ADDENDUM No. 5

RFP No. 24-23

Barton/Bandemer Park Pedestrian Tunnel Project

CITY OF ANN ARBOR PRS & WASHTENAW COUNTY PRC
BARTON/BANDEMER PARK PEDESTRIAN TUNNEL PROJECT
AESTHETIC TREATMENT DETAILS

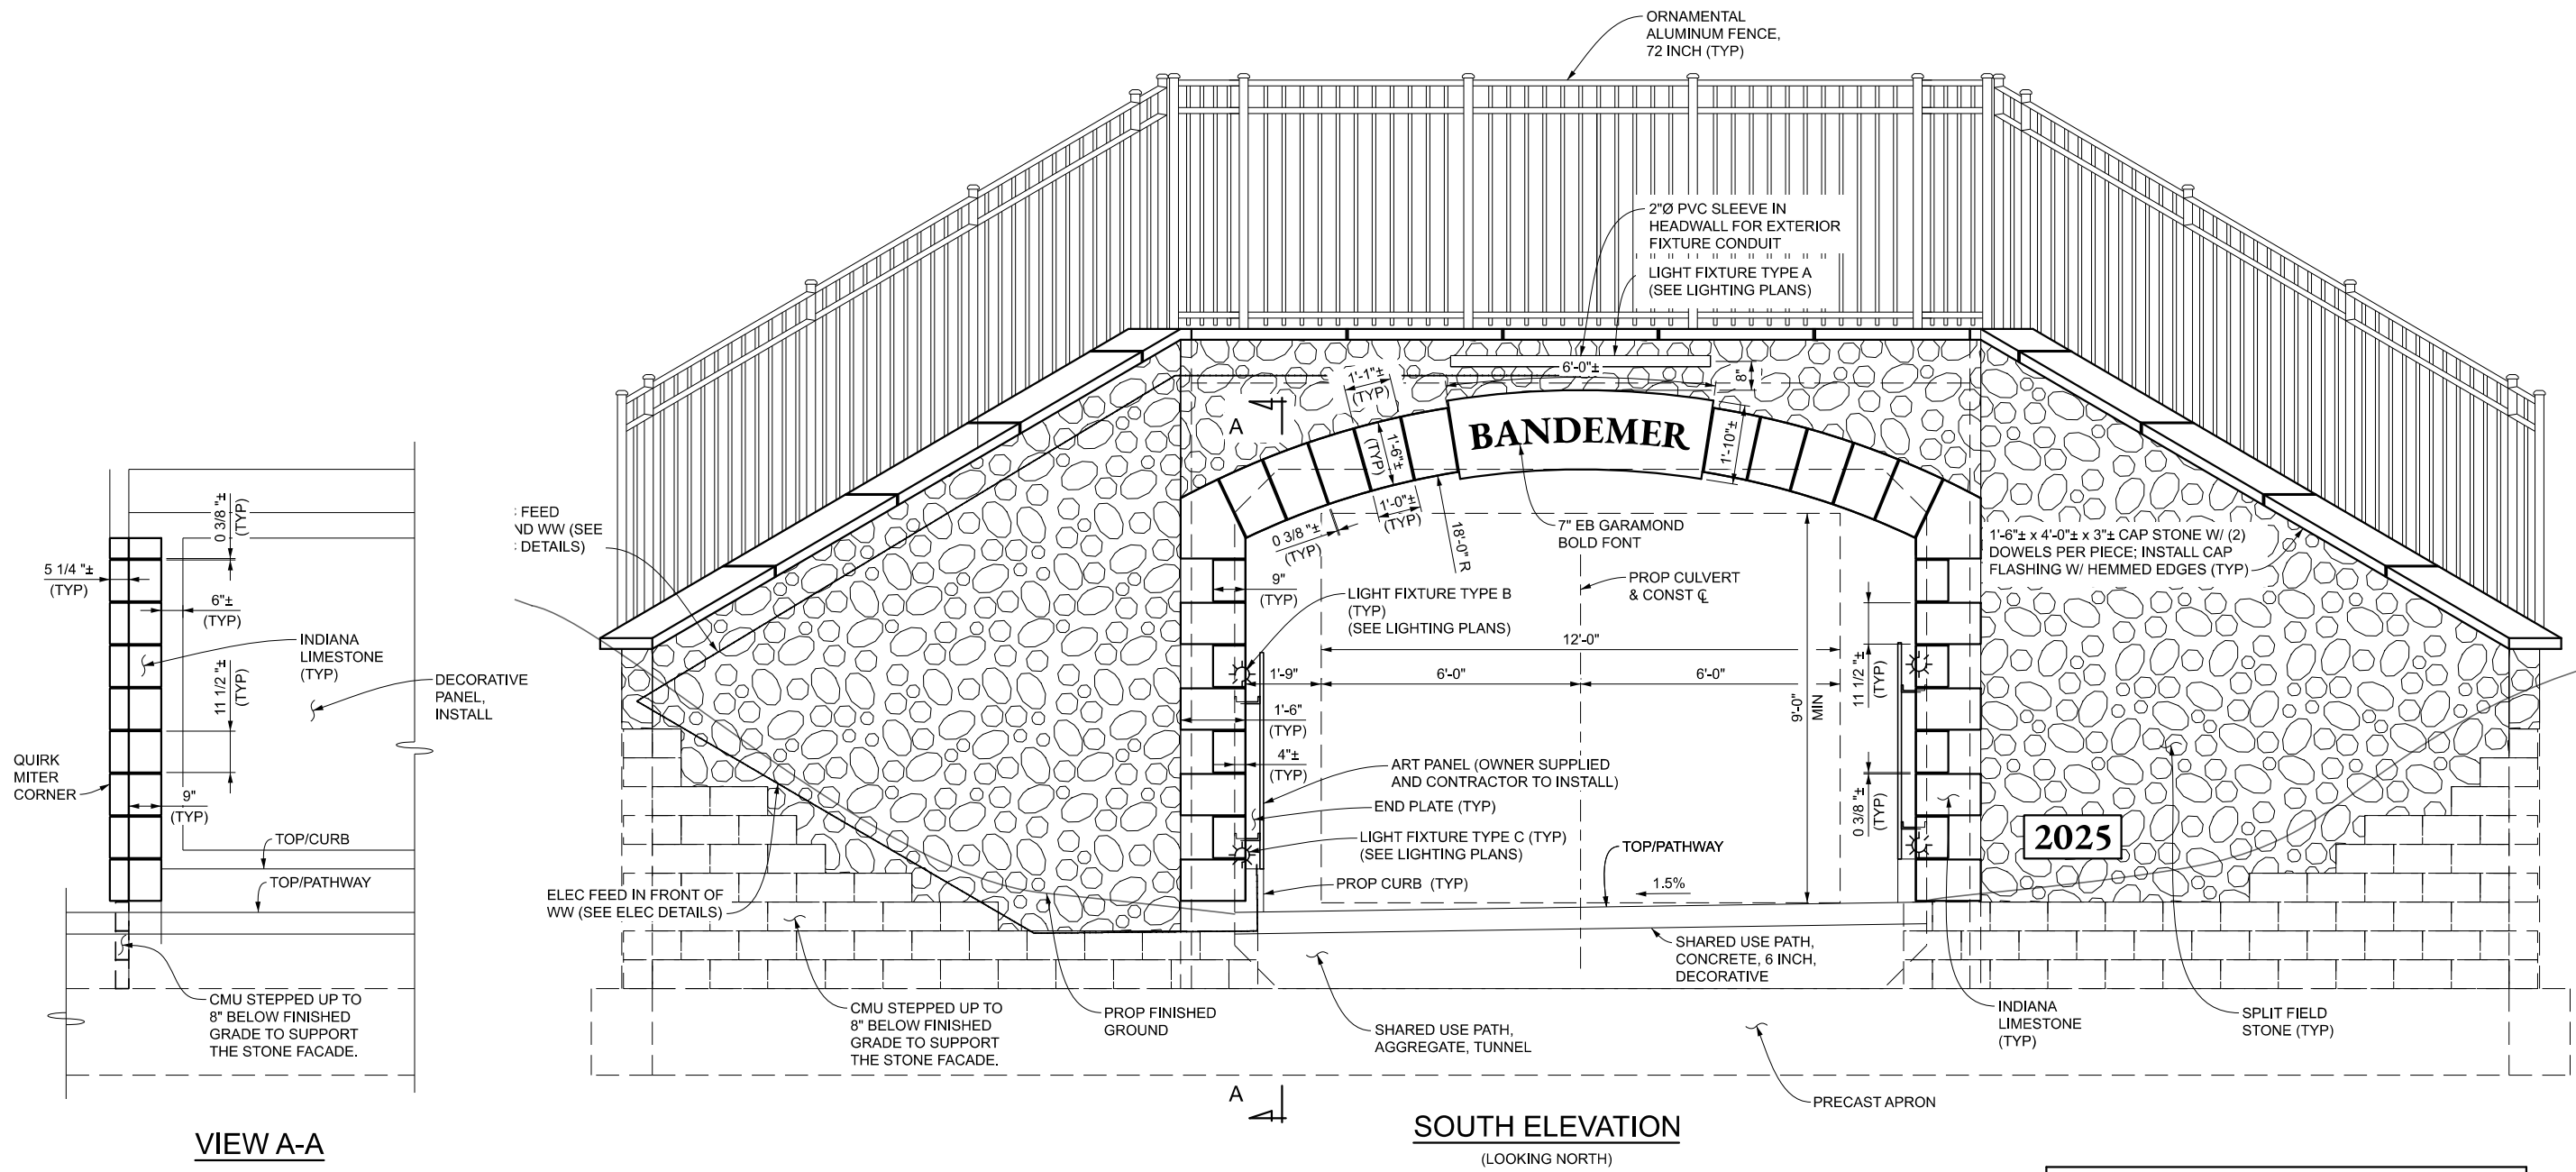
Plans Page 49 of 80

Replace plan sheet. Sheet revised to update pay item for limestone date sign.

MISCELLANEOUS QUANTITIES		
117	Ft	Limestone Cap
132	Sft	Limestone Block
637	Sft	Split Field Stone
1	Ea	Limestone Sign, "Bandemer"
1	Ea	Limestone Sign, "Barton"
2	Ea	Limestone Sign, "2025"
